# Redfern Mixed Use Co-Living Housing Development

State Significant Development Assessment Report (SSD 32275057)

July 2024

**Figure 18** | Eveleigh Street elevation (hatched section showing reduction of height and building mass from uppermost level from EIS scheme to current scheme).

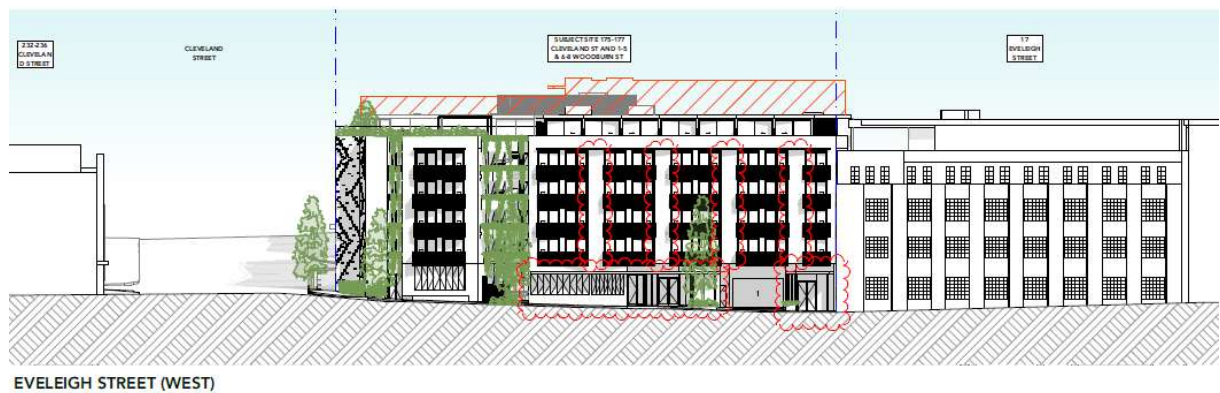
60. In response, the Applicant amended the proposal by reducing its height from seven storeys to six storeys as well as reducing the massing and increasing the setbacks of the upper level. The Applicant also submitted a written request under clause 16A of Appendix 3 of SEPP (Precincts – Eastern Harbour City) 2021, justifying the proposed one-storey height

61. The Applicant noted that the proposed one-storey exceedance results from redistributing the allowable GFA in a manner that is consistent with the locality's built-form character while allowing for improved residential amenity for future occupants.
62. The Department's detailed consideration of the Applicant's variation request is provided in **Appendix E**. In summary, the Department supports the amended proposal as well as the Applicant's request to vary the building height development standard because the proposal:

- is similar in height as the adjoining building at No 13 - 17 Eveleigh Street as viewed along Eveleigh Street (see **Figure 18**)
- complies with the maximum permissible floor space for the site (see **Section 6.1 – Land Use**) and allows for the better distribution of floor space to accommodate a large internal courtyard and rooftop communal facilities to support good residential amenity (see **Section 6.3.1 - Internal Building Separation** )

**Figure 19** | Internal building separation

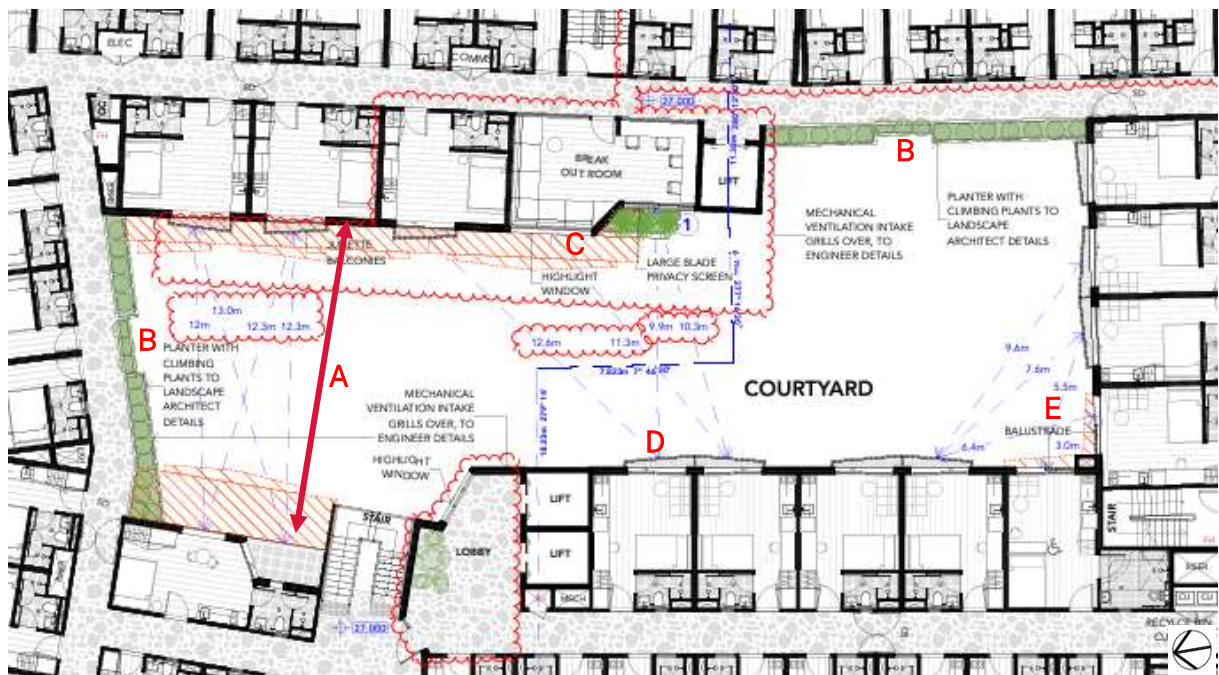
69. Council initially raised concerns that the internal building separation did not meet the minimum 12 m requirement recommended by the ADG. Council also noted that the proposed use of screens, landscaping, and Juliette balconies would not provide sufficient privacy and may adversely affect natural and cross ventilation.

70. In response, the Applicant amended the proposal by removing several rooms adjoining the internal courtyard/ void to ensure the proposal achieved a minimum internal separation distance of 12 m between directly facing rooms (see **Figure 19**).

71. The Department considers the amended proposal would support a reasonable level of privacy for future residents, because:

- the revised 12 m separation between co-living rooms is consistent with objectives and requirements of the ADG to maintain visual privacy (see note **A** in **Figure 19**)
- landscaping has been incorporated along the internal corridors to minimise privacy impacts on adjacent rooms and improve outlook (see note **B** in **Figure 19**)
- the break out spaces incorporate a combination of highlight windows, landscaping and privacy screening to prevent direct views into opposing co-living rooms (see note **C** in **Figure 19** and **Figure 20**)
- the revised 12 m separation means the proposed julliet balconies are no longer required to incorporate privacy screening (see note **D** in **Figure 19**)
- the south-western internal rooms are angled to avoid directly facing each other to ensure privacy is maintained (see note **E** in **Figure 19**).

**Figure 20 | Break-out space privacy measures**

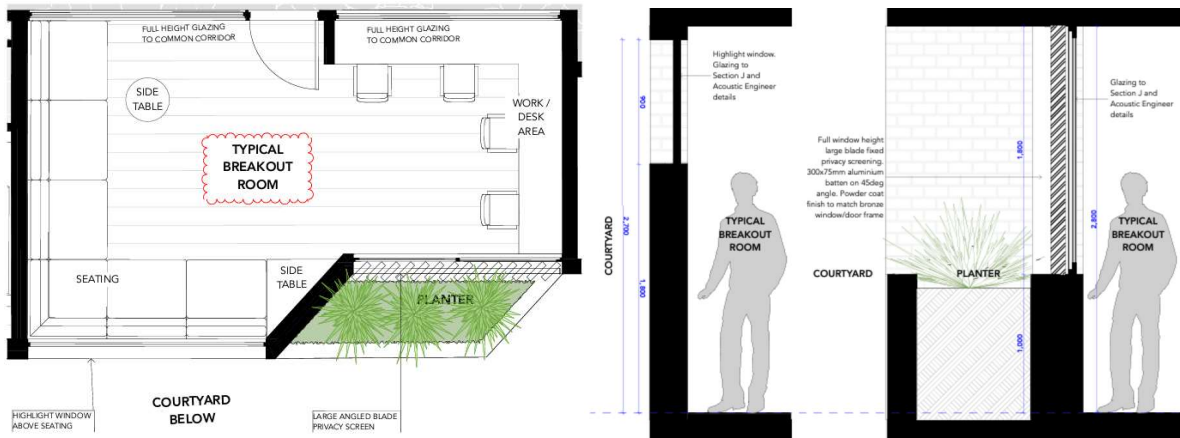
72. The Department considers the proposed privacy measures, together with the increased building separation, strike a good balance between maintaining visual privacy, allowing for appropriate ventilation and improving views from the rooms to the expanded internal courtyard. As such, the Department is satisfied that the proposal aligns with the building separation requirements outlined in the SEPP (Housing) 2021 and the ADG, and the proposal would support an acceptable level of visual privacy.

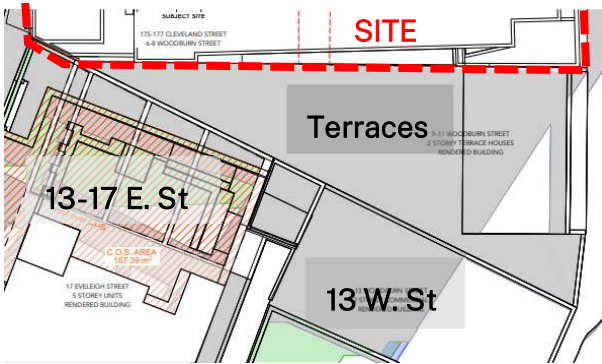
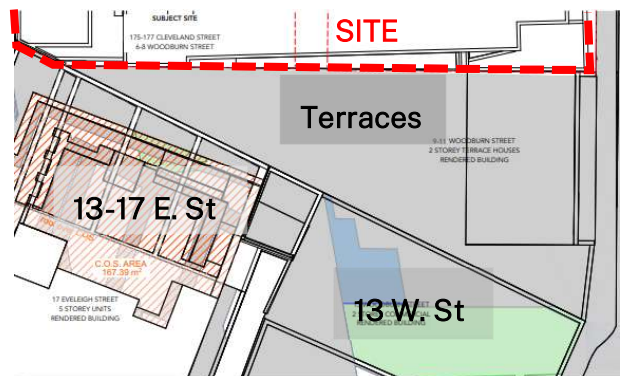
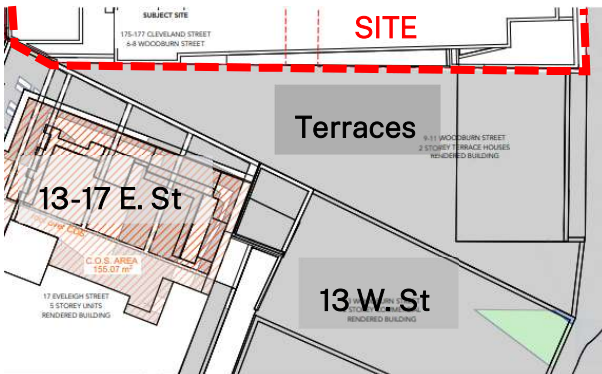
83. The Department received two public submissions raising concerns the proposal would overshadow the adjoining terraces along Woodburn Street.
84. In response, the Applicant amended the proposal by removing a storey and reducing the massing of the subsequent upper level. The amended proposal was also accompanied by additional solar diagrams illustrating the extent of the overshadowing impacts to surrounding properties (see **Figures 21** and **22**). The Applicant's full set of solar diagrams can be viewed at **Appendix A**.

86. The Department acknowledges the overshadowing concerns raised by the adjoining terraces. However, the Department notes that the existing four-story development located on the site already overshadows the adjoining terraces during midwinter due to its orientation being immediately north of the terraces. The submitted additional shadow diagrams illustrate the overshadowing impacts of the proposal compared to the existing building would not materially change in respect to the terraces (See **Figure 22**).

**Figure 23 | Ground floor plan**

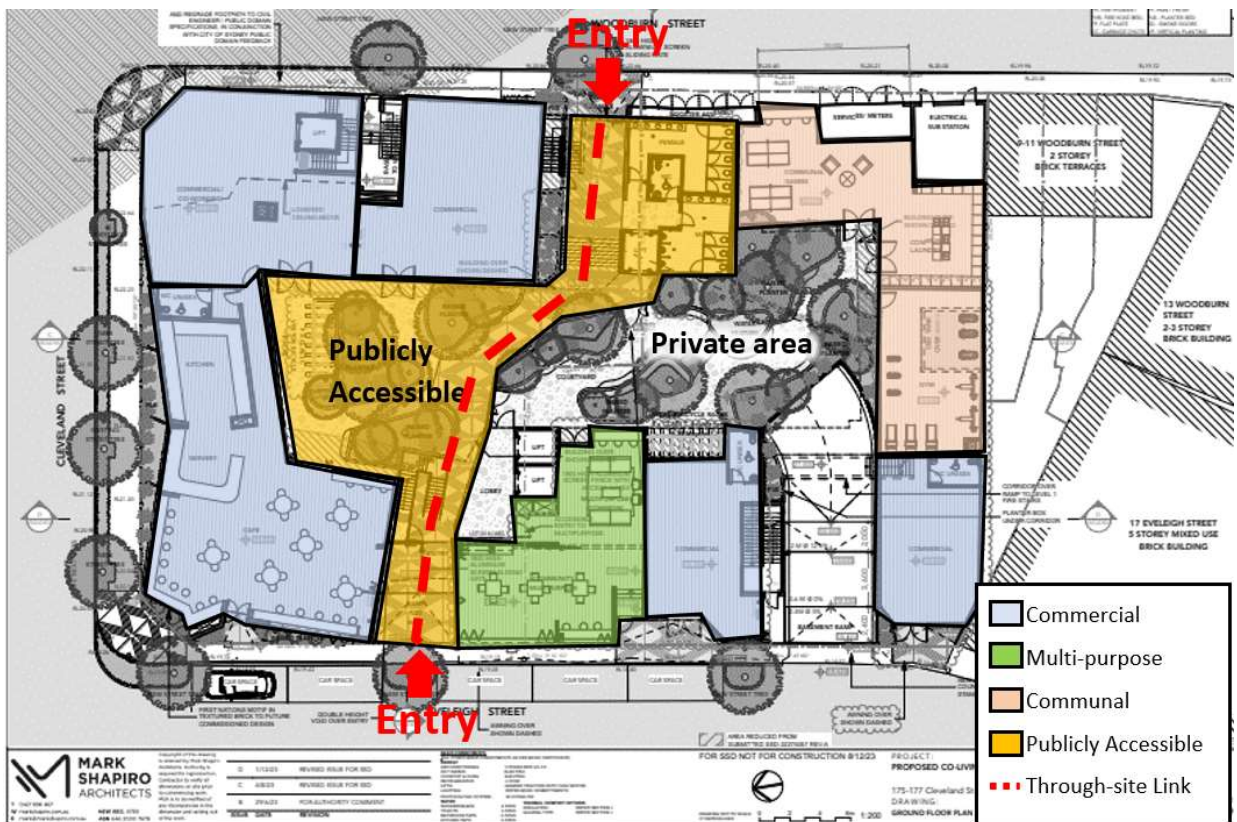
91. In response, the Applicant amended the proposal to include additional commercial tenancies along Eveleigh Street to improve street activation. The design and orientation of the proposed multi-purpose community room were also amended to have a direct street frontage to Eveleigh Street, improving community access and street presence (see **Figures 23 and 24**).
92. The Applicant argued that, due to the site's uneven topography, the northeast corner of the ground floor is partially below street level, which allows for two levels of commercial space to be provided.

95. The proposal includes a pedestrian link from Eveleigh Street to Woodburn Street, through the internal courtyard (see **Figure 23**).
96. Council raised concerns the proposed through-site link is time-restricted and is not designed to support good visibility and safety for both public and residential use.
97. The proposal was reviewed by the State Design Review Panel who commented that the link should be purposeful and provide a clear route between destinations that feel public and safe.

104. Council also considered the proposed through site link is not a genuine public link as it does not provide a clear line-of-sight, with an angled path, recommending a more direct route through the site should be provided.

93. The Department considers the amended proposal appropriately addresses the issues raised in Council’s submission and would provide a suitable public domain interface and transition, including management between the residential and non-residential uses because:
- the ground floor includes the provision of commercial, community and communal uses that would provide both good street activation and passive surveillance of the internal courtyard
  - fencing and landscaping is proposed to delineate, where necessary, between private and publicly accessible areas of the courtyard.
94. The Department is therefore satisfied that the proposal appropriately activates the adjoining public domain and includes acceptable delineation between the public and private areas.

98. In response, the Applicant reconfigured the layout of the proposed through-site link, amenities and commercial tenancies to improve the line of sight and legibility of the through-site link. The Applicant contends that the proposed through-site link would provide an opportunity for pedestrian connectivity and contribute to the proposed co-living/ working model. However, it is not intended to function as a pedestrian link for public use 24 hours a day.

99. The Applicant also provided an updated Plan of Management clarifying the internal ground floor courtyard will be available for passage by the public seven days a week, between 7am and 9pm.

**Figure 25 |** Basement floor plan – 6.4m SRV turning path

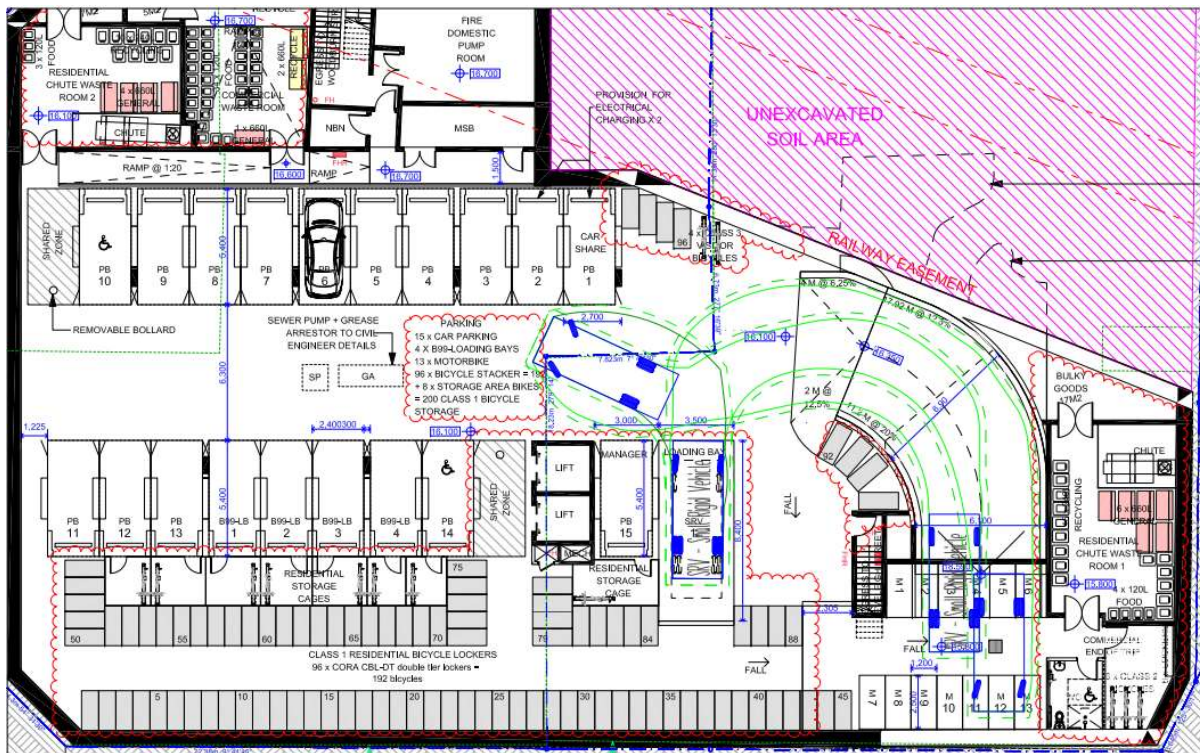
121. The proposal would provide loading and serving arrangements, including waste collection within the basement car park.
122. Council originally raised concerns that the proposed servicing bay does not allow Council's waste vehicles to access and exit the site in a forward direction. Council also advised that waste generation should be recalculated based on the size of bins collected by Council's waste vehicles.

123. In response, the proposal was amended to be serviced by a private waste contractor. Council objected to private waste collection for a predominately residential development.

125. The Department also notes the amended proposal is accompanied by additional swept path diagrams demonstrating loading and servicing vehicles, including a 6.4 m SRV for waste collection can enter and exit the site in a forward direction (see **Figure 25**).

126. The Department is therefore satisfied the proposal has adequate provisions for loading and servicing and has recommended conditions requiring on-going provisions for private waste collection.
